## PUBLIC COMMENTS FOR IBR EXECUTIVE STEERING GROUP

*Received between October 21, 2024 and March 6, 2025*

ESG Public Comment, meeting March 6, 2025

**Showa Bridge Niigata, Japan 1964**

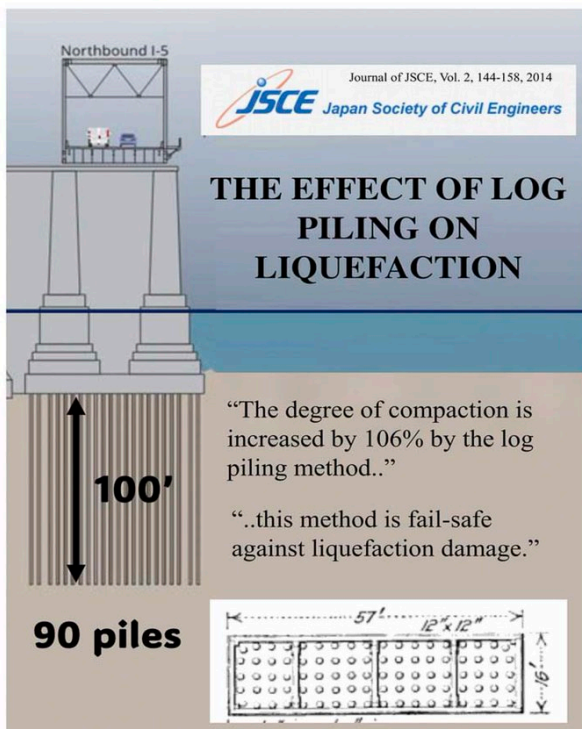
**THE EFFECT OF LOG PILING ON LIQUEFACTION**

“The degree of compaction is increased by 106% by the log piling method..”

“..this method is fail-safe against liquefaction damage.”

The IBR claims that liquefaction will cause the I-5 bridges to fail, similar to the Niigata Bridge in Japan, which had only nine 52-foot-long, widely spaced piles per pier. In contrast, the I-5 bridges have 100-foot-long, tightly spaced wood piles (90 per pier) that compact the soil, making them resistant to liquefaction.

A Japanese study has demonstrated that closely spaced wood piles enhance soil compaction and serve as a "fail-safe against liquefaction damage." The IBR plans to use only six drilled shafts per pier, which will not effectively improve soil compaction. Additionally, the IBR's bridge design may be less resilient to earthquakes than the current I-5 bridges. The IBR's bridge trusses will be twice as long, twice as wide, fifty feet higher, and five times heavier. Its 120-foot piers will rest on only six drilled shafts (up to 250 feet long) in uncompacted soil.
